Your Vehicle: 1999 Jaguar XK-8 Convertible (X100) V8-4.0L (AJ27)

[Vehicle](#) » [Technical Service Bulletins](#) » [All Technical Service Bulletins](#) » [Headlights - Condensation](#)[Notes](#)**Headlights - Condensation**

417-05

[Headlamp](#) Misting - Improve Ventilation - Repair Procedure

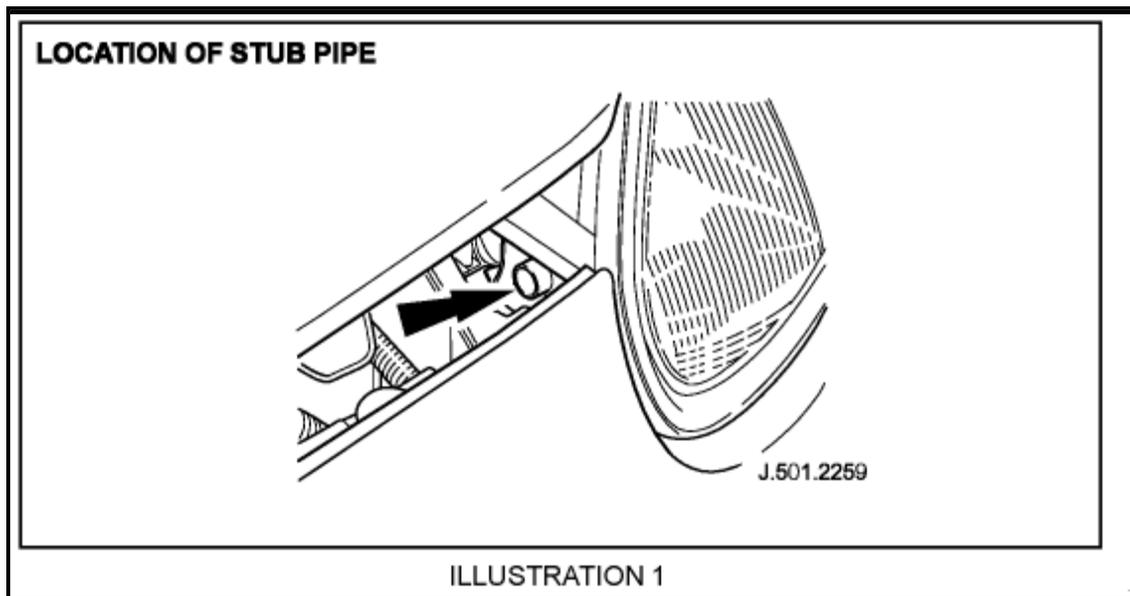
1. Inspect [headlamp](#) to see if stub pipe is present (Illustration 1).

Note: If stub pipe is present, continue with workshop procedure from step 2, if stub pipe is not present, obtain a new headlamp assembly and continue from step 3.

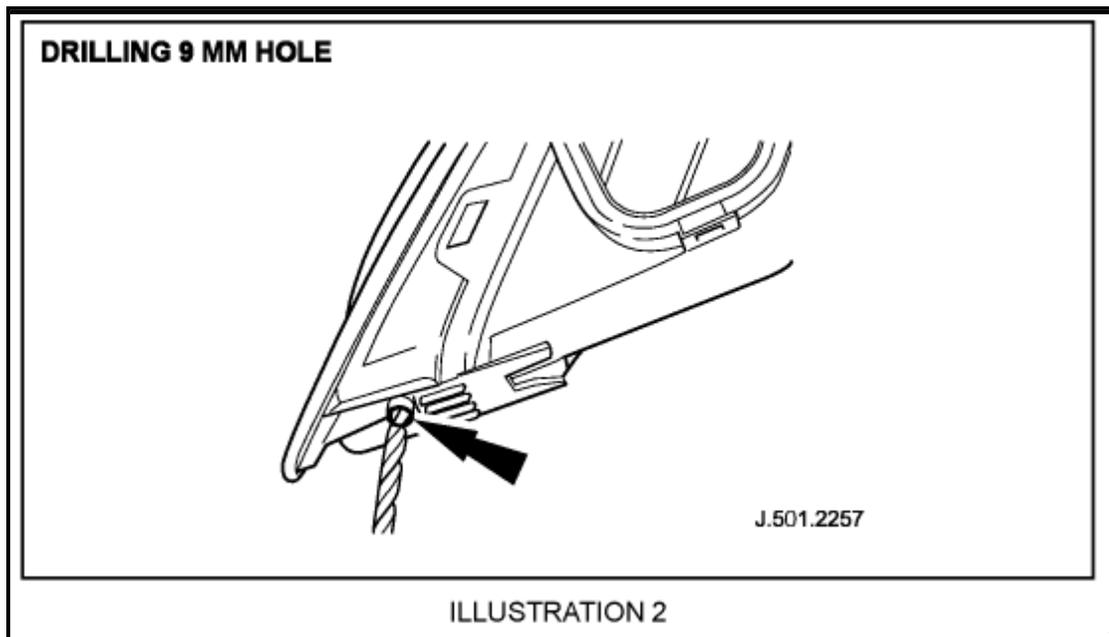
4. Carefully drill a 9 mm diameter hole upwards into [headlamp](#) using the stub pipe as a guide (Illustration 2).

Note: Maintain [headlamp](#) in the same orientation as for the drilling operation and shake out any drilling debris ensuring none remains in the headlamp.

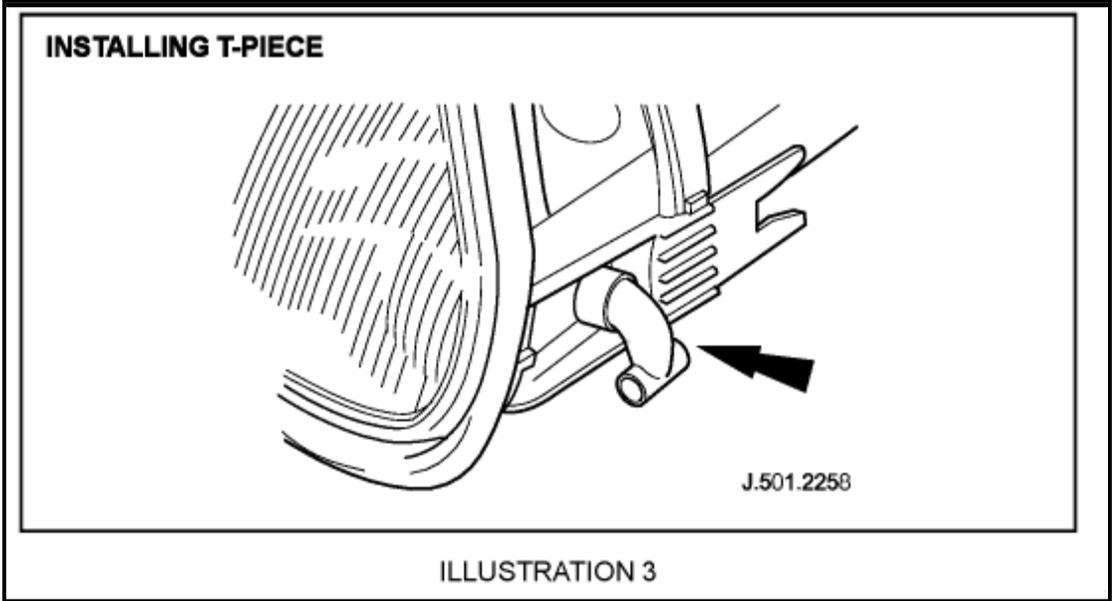
6. Install and align T-piece to stub pipe (Illustration 3).

Note: Ensure headlamp stub pipe and T-piece mating surfaces are free from oil and grease.
